# ENGINEERING MEMORANDUM

TITLE <b>REPAIR - FLAP GEAR BOX GEAR</b>		E.M. NO. 11994 "8"	FILE CODE 111-41
PART NO. 187796-2		EFFECTIVE <b>Immediately</b>	
PART NAME <b>Flap Gear Box Gear</b>		DWG. NO.	COPIES TO NO.
USE OF E.M.		JOB NO.	ENG. 2
SALVAGE <input checked="" type="checkbox"/>	DISPOSITION OF STOCK	CUSTOMER'S ORDER NO.	INSP. 6
CONCESSION			PROD. 9
STOP ORDER/RELEASE	CHECK BLOCKS AFFECTED	CUSTOMER <b>RCAF</b>	PLANNING 2
NEW DRAWING			REWORK
REVIS. DRAWING	NOT AFFECTED	TYPE AIRCRAFT <b>Expeditor 3</b>	CONT. ADM. 1
VARIATION	USE TO DEPLETION		R.C.A.F. 3
OBSOLETE NOTICE	REWORK	AIRCRAFT REGISTRATION NO.	ESTIMATING 1
USE AS NOTED <input checked="" type="checkbox"/>	SCRAP		DATE May 31/56
	AS NOTED	DWG. CHANGE	DWG. CONT. 3
		YES <input type="checkbox"/> NO <input checked="" type="checkbox"/>	
APPROVALS	ORIGINATED BY <i>H. R. ...</i> B. A. W. PROJ. ENG.		
	<i>R. ...</i> B. A. W. INSPECTION		
	<i>J. ...</i> ENGINEERING	<i>E. ...</i> CONTRACTS ADMIN.	<i>J. ...</i> CHIEF

**-3 BUSHING ~ 1 REQ.**  
**BRASS ROD QQ-B-636a-2**  
**SLIGHT PRESS FIT**  
**INTO GEAR**

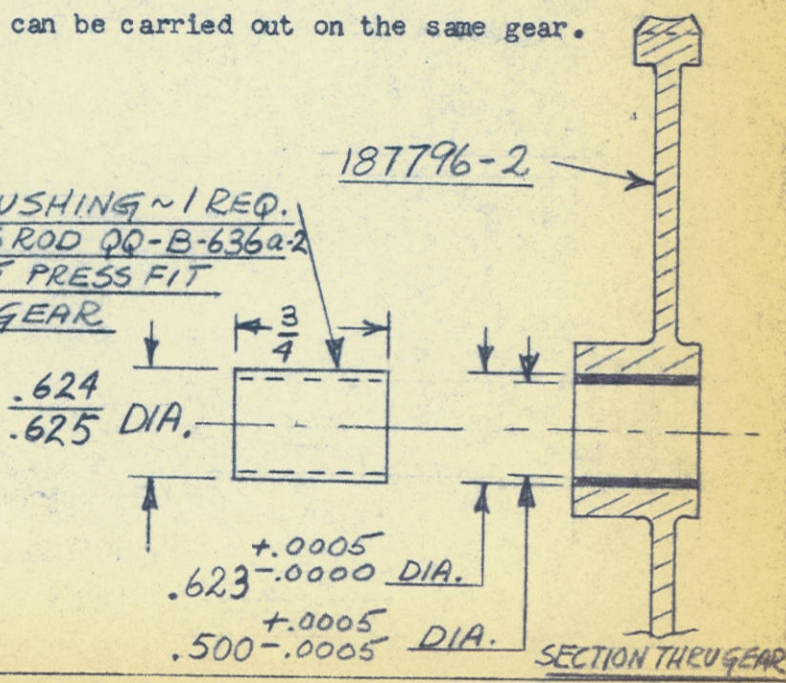
Several cases have been experienced where the flap gear box gear has elongated taper pin hole and/or elongated hole for the gear shaft.

- Elongated taper pin hole.  
Redrill 90° to existing hole.
- Elongated hole for gear shaft  
Drill out and rebush as shown in sketch below. If the flange is cracked, rebushing is not to be carried out. GEAR IS IN SUCH CASES TO BE REJECTED.
- Repair as in para. 1 and 2 can be carried out on the same gear.

**ISSUE B - ALTERNATE**  
**MATERIAL: SAE 72**  
**BRASS QQ-B-626**  
**1/2 HARD.**
